ADDENDUM NO: 1

PROJECT: **SITE IMPROVEMENTS AT FRANKLIN CENTRAL JUNIOR HIGH**

CONTEXT PROJECT NO: 22-1613 DATE: 2/13/2024 BY: Fred Prazeau

Sheet No:
C110

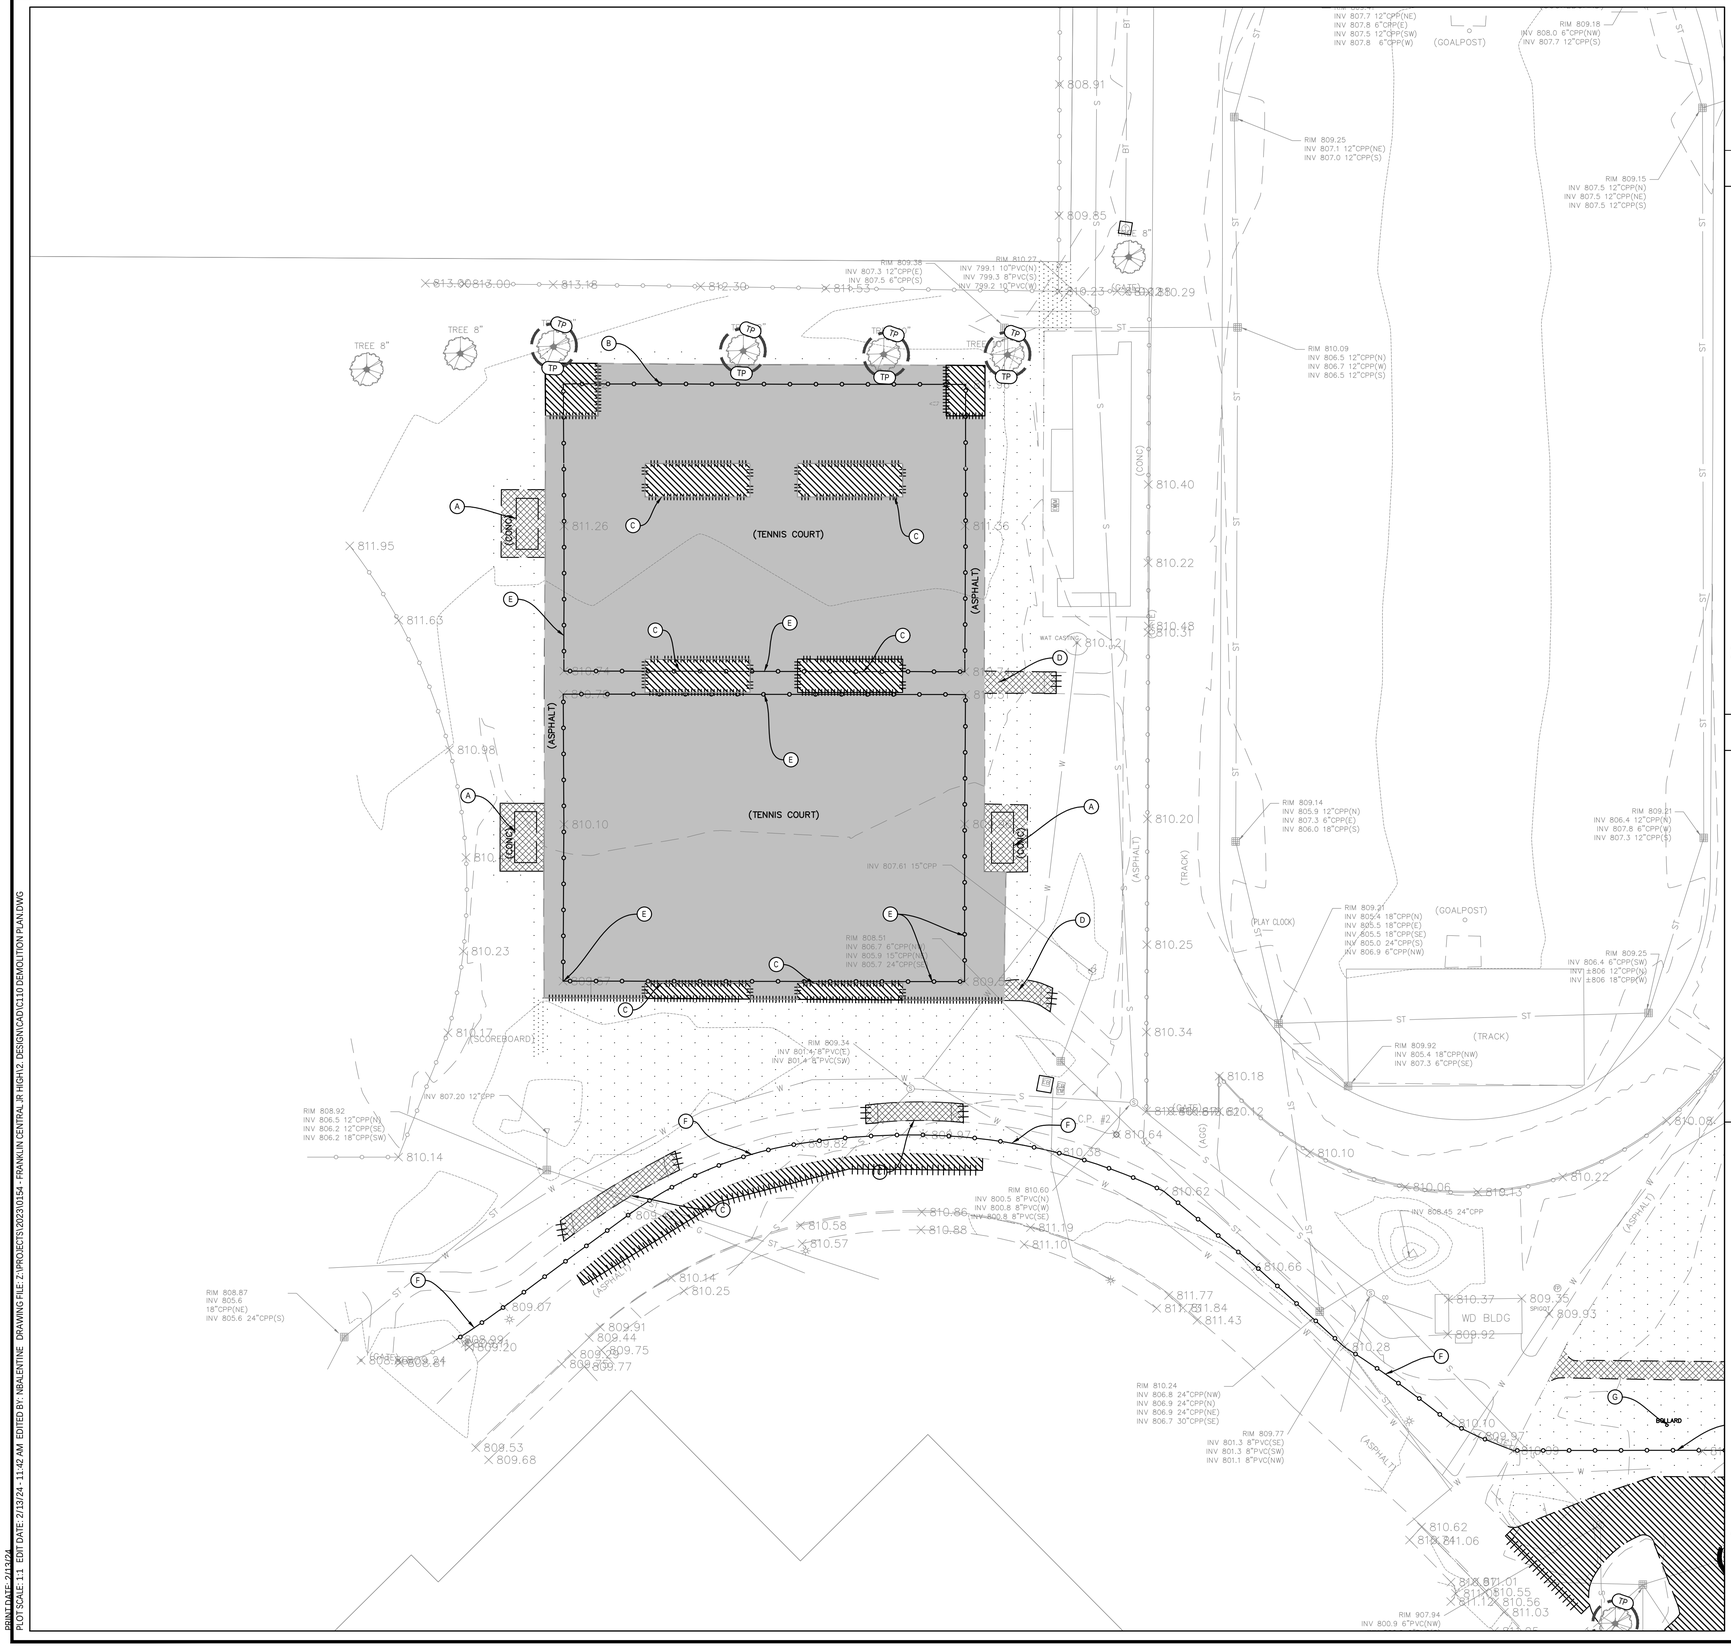
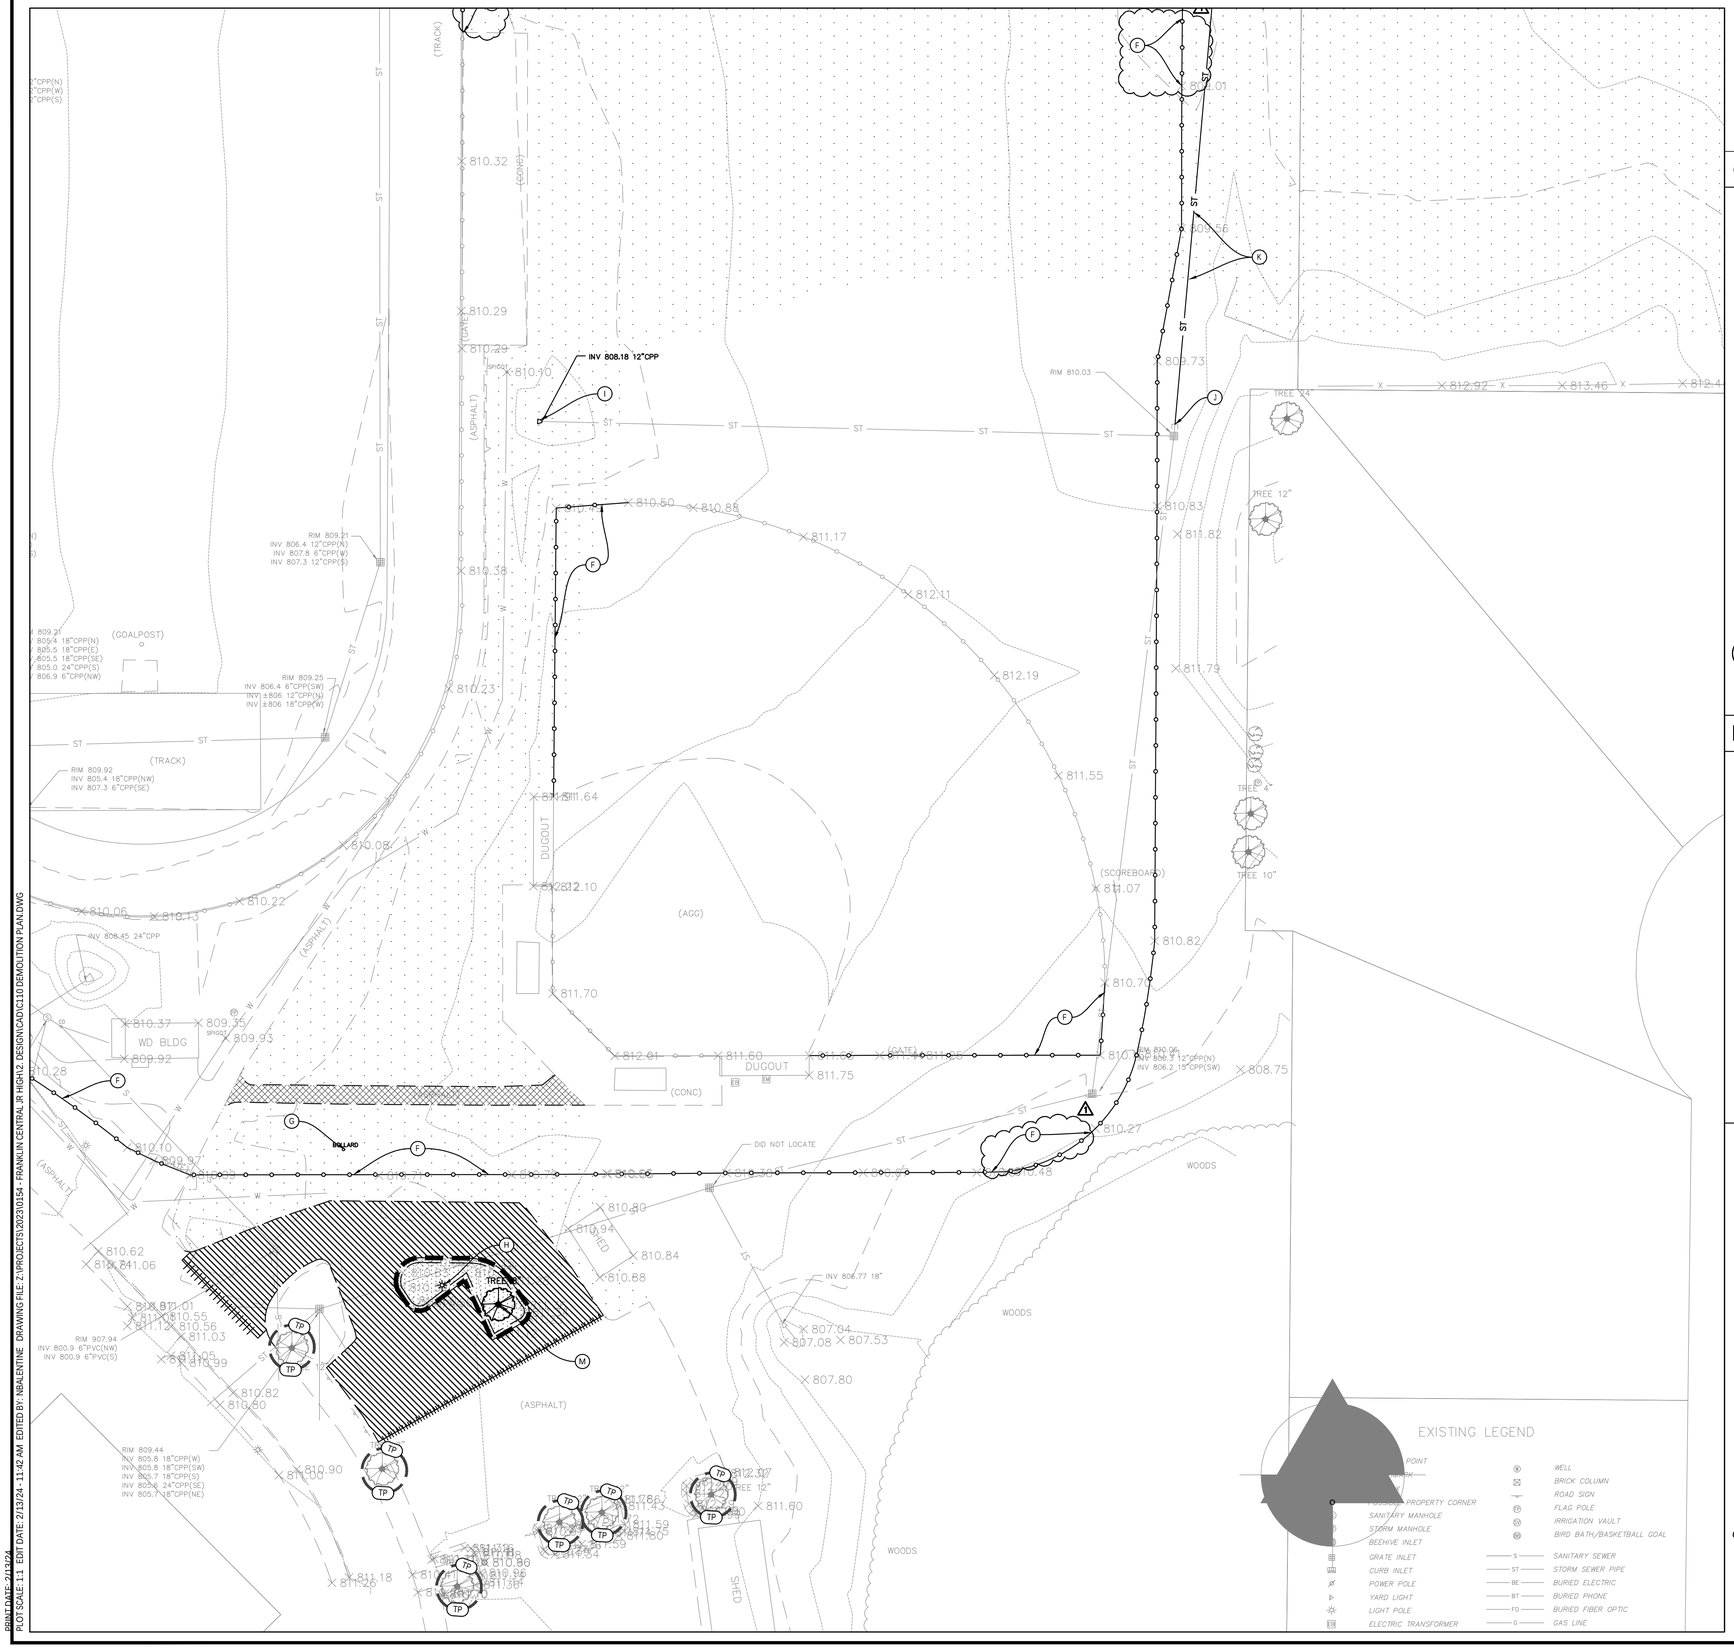
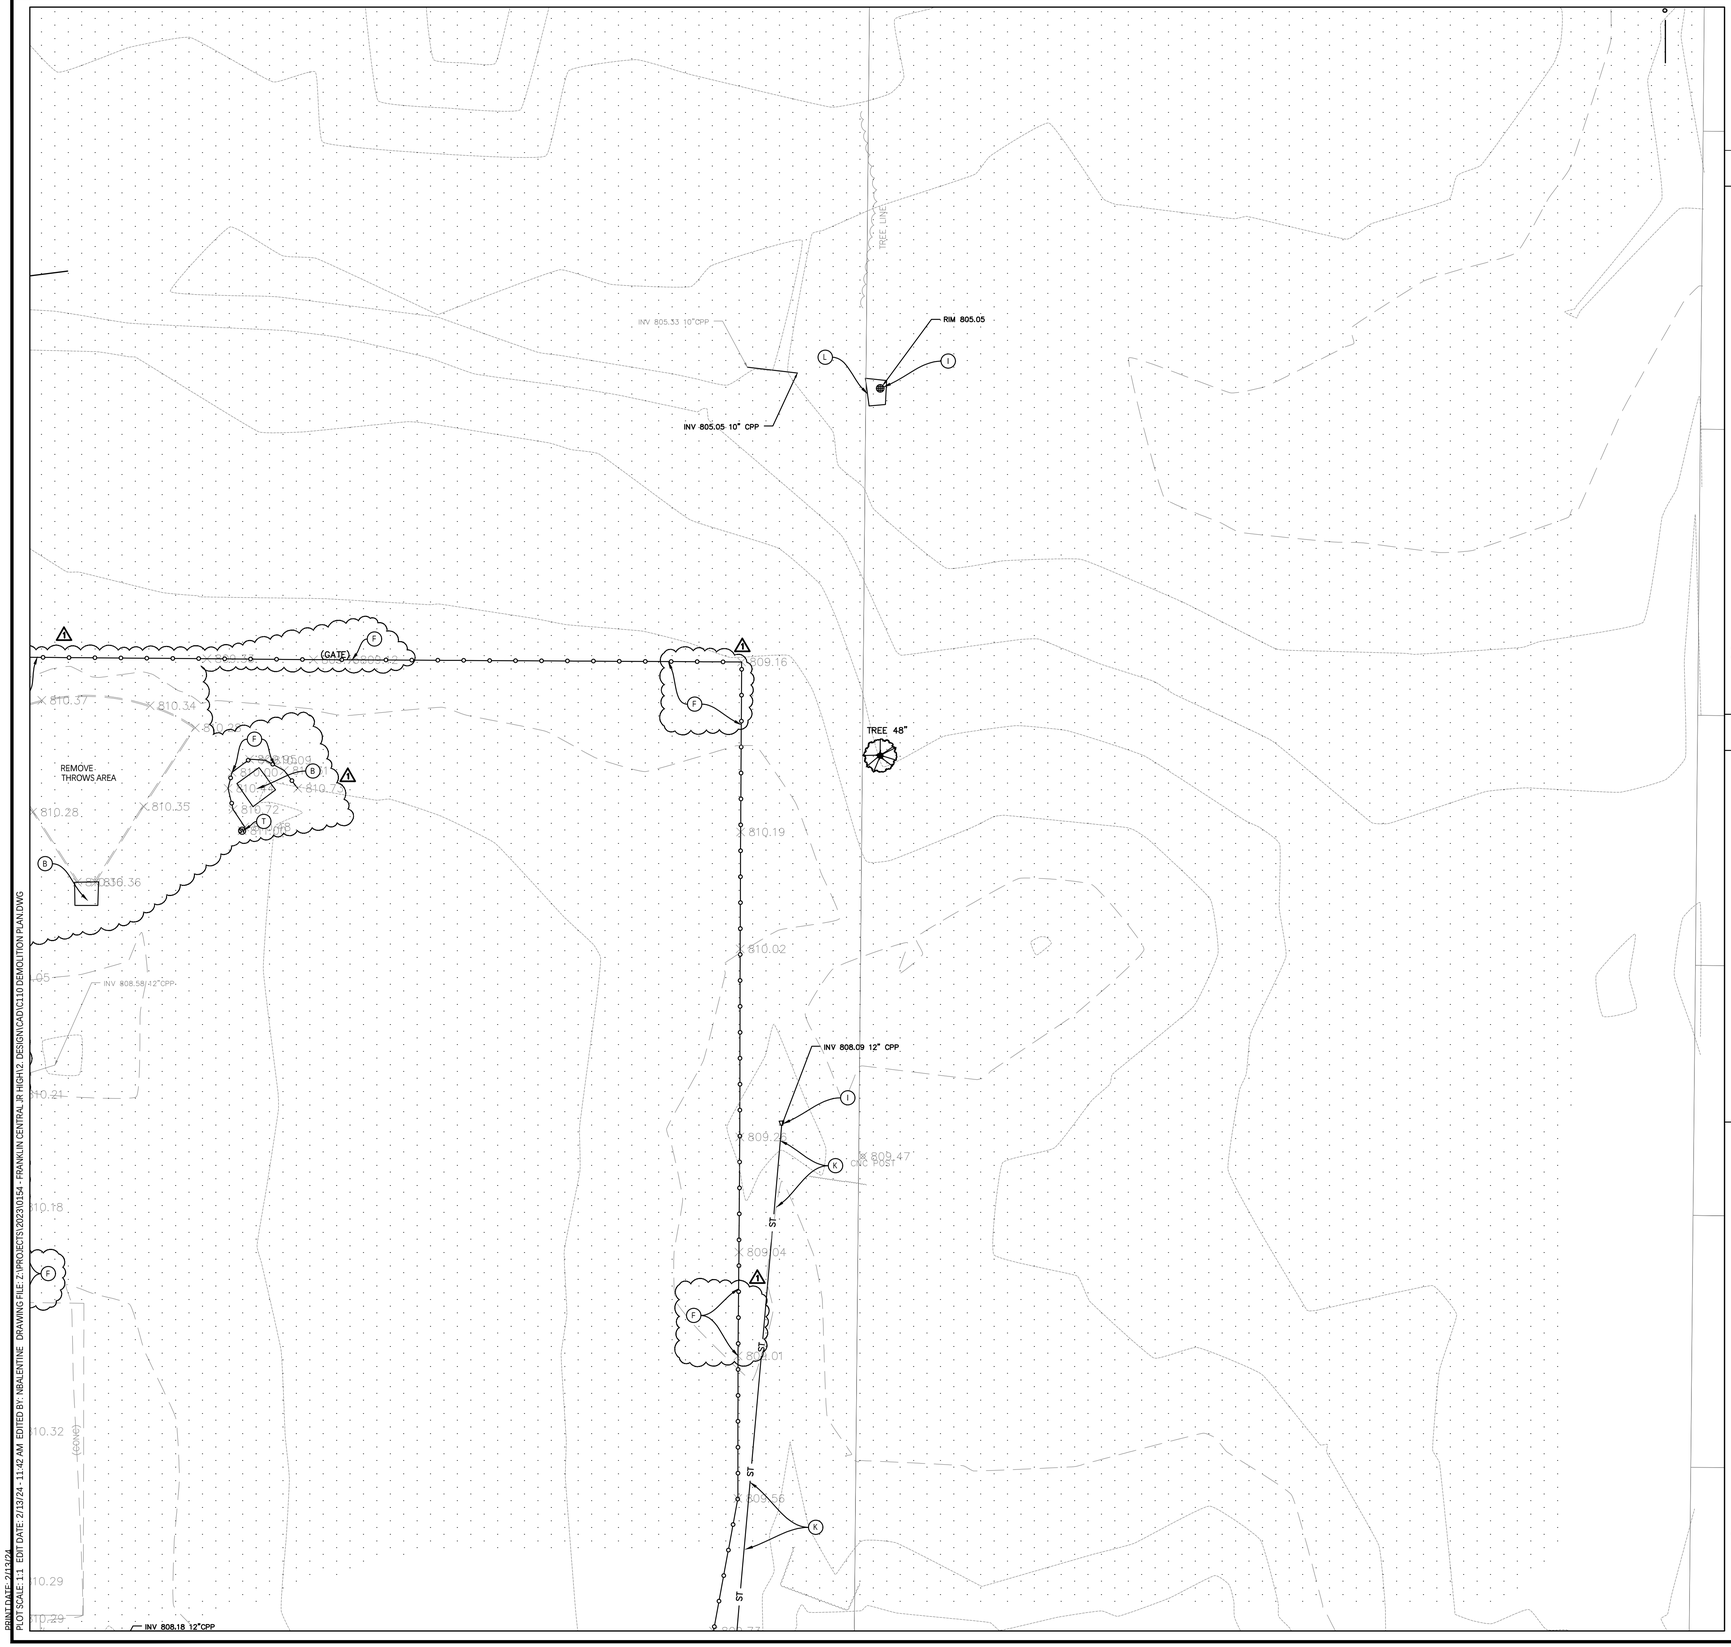
1. C110-Series Demolition Plans reissued to address City comments, including clarification on fence and gate removal, throwing area removal, and relocation of sprinkler vault.
